MINUTES OF THE 16TH MEETING OF THE RE-CONSTITUTED EXPERT APPRAISAL COMMITTEE (EAC) ON ENVIRONMENTAL IMPACT ASSESSMENT (EIA) OF THERMAL POWER PROJECTS

The 16th Meeting of the re-constituted EAC (Thermal Power) was held on 19th April, 2018 in the Ministry of Environment, Forest & Climate Change at Brahmaputra Meeting Hall, Vayu Wing, First Floor, Indira Paryavaran Bhawan, Jor Bagh Road, New Delhi under the Chairmanship of Dr. Navin Chandra. The following members were present:

9. Lean slurry discharge

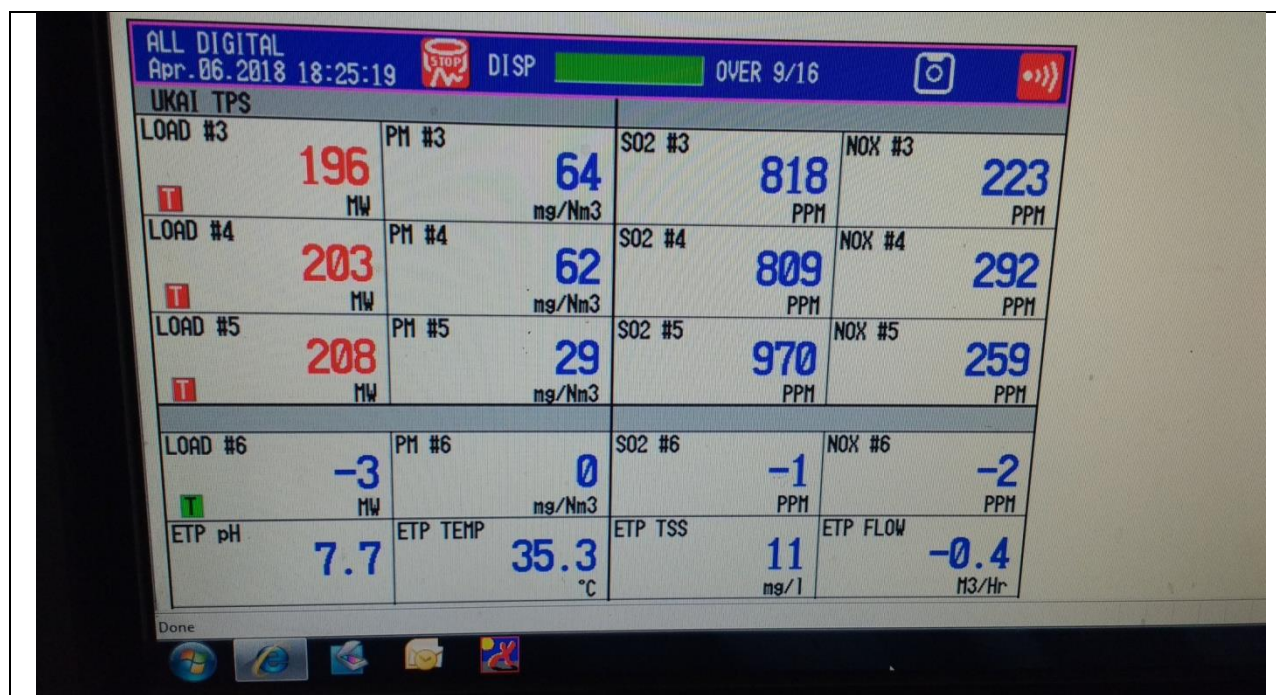
- iii. Ash is being dumped in dry form at several places. Hazardous waste, municipal solidwaste is mixed with flyash.
- iv. At several places, bunds were made of ash which can flow into the water body during monsoon.
- v. Effluent Treatment Plant is not functioning.
- vi. PM emissions in the stack are within the limit (100 mg/m³).
- vii. SO₂ and NO_x emissions are high for which CPCB granted extension up to 2022.
- viii. Huge water drawal of approx. drawing 1.45 Million m³/day water is being done Ukai left bank canal which is meant for irrigation. However, majority portion is discharged into the canal. Cooling tower is installed for Unit-6 (800 MW). Remaining units, once through cooling is done. Monitoring of quantity

- ix. Fugitive dust emissions observed from the haul roads leading to ashdyke.
- x. Greenbelt on the bunds and periphery of ashponds and power plant is almost Nil.
- xi. Nearly 50,000 m³/day is being discharged into the water bodies. In the upstream of the water bodies, paper mill discharge is contributing to the pollution load than the power plant discharge.

- i. Ash water recirculation is to be done. Treatment of wastewater and reuse shall be explored.
- ii. Solid waste and hazardous waste should be segregated and not to be dumped with ash. Quantification and waste management plan shall be submitted.

- iv. Effluent Treatment Plant should be made functional and effective. Effluent monitoring is to be regularly carried out.
- v. Continuous water sprinkling is to be done along the haul roads to arrest air borne dust. Roads shall be black topped.

- vi. Water sprinklers may set up in the ash pond as the dry ash pond should not get carried by air currents.
- vii. Strengthening of environment management cell to be done at the plant site as well as corporate office by engaging qualified environmental staff to meet the environmental compliance and for implementation of environmental mitigation measures.
